ADDENDUM # 1
UC Merced Medical Education Building Project
Environmental Impact Report
State Clearinghouse Number 2021040047

Changes to the UC Merced Medical Education Building Project

April 28, 2023

FIGURE 3-2

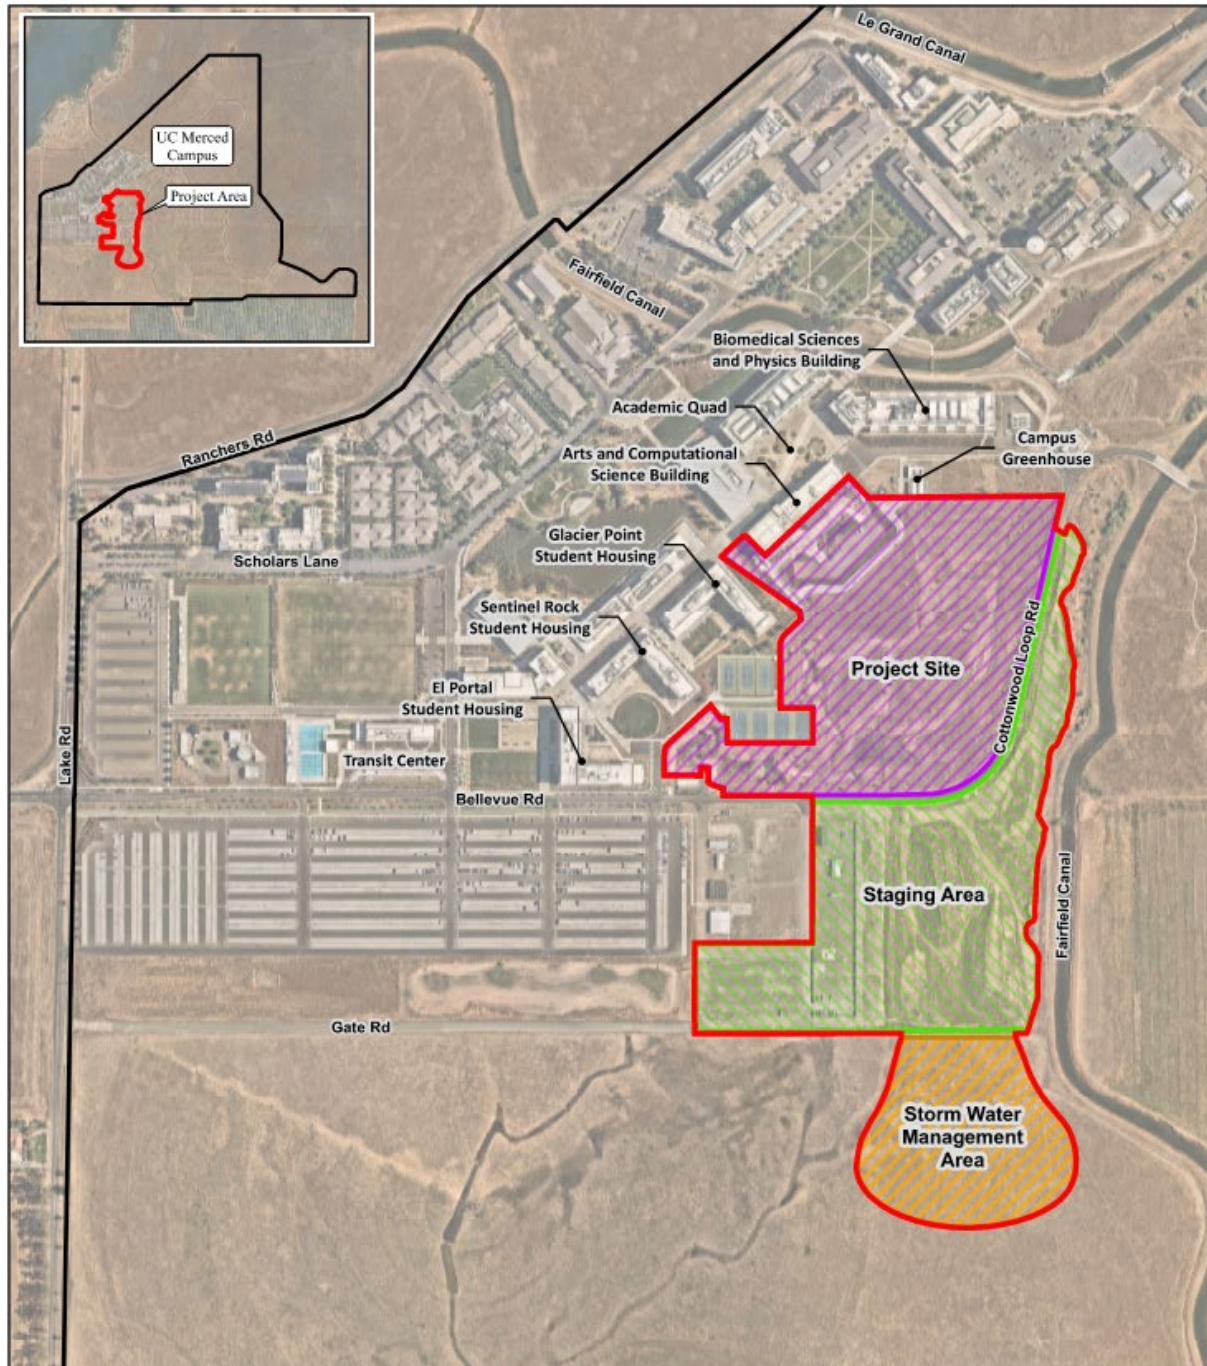
In conjunction with the revised building design, the site plan has been revised to eliminate certain pathways while other pedestrian pathways have been modified. The parking lot is still of the same size as before, but its location and layout has been revised as has also the alignment of the access roadway that would connect the new building to Cottonwood Meadow Loop Road. As a result of these minor changes to the site plan, the total amount of impervious surfaces that would be added by the Project has changed from 4.3 acres to 4.4 acres, although the building footprint has decreased from 2 acres to 1.53 acres. The overall 43.5-acre Project Area, comprising the building site, the area that would be used for construction staging, and the area where the proposed storm water detention basin would be located, is substantially unchanged from before.
